10/561,893

Johann Eberle

Office Action Summary	Application No. 10/561,893	Applicant(s) EBERLE ET AL.	
	Examiner RYAN DODD	Art Unit 4134

U.S. Patent Dec. 22, 1993 Sheet 1 of 6 5,172,798

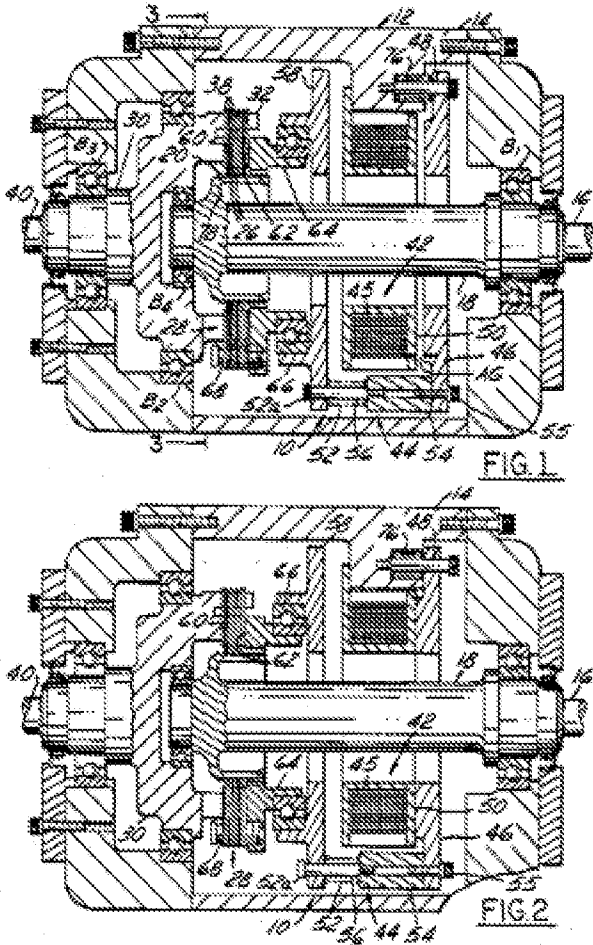
side walls of brake housing or solenoid support housing, respectively, so as to obtain the greatest possible distance between such bearings.” Mabee ‘798 discloses a shaft (drive shaft 16) of brake rotors (annular discs 26, see column 1, lines 43-45, and lines 51-55) and is supported by bearings (B1 and B3) disposed in opposite side walls of brake housing (housing 14) so as to obtain the greatest possible distance between such bearings.
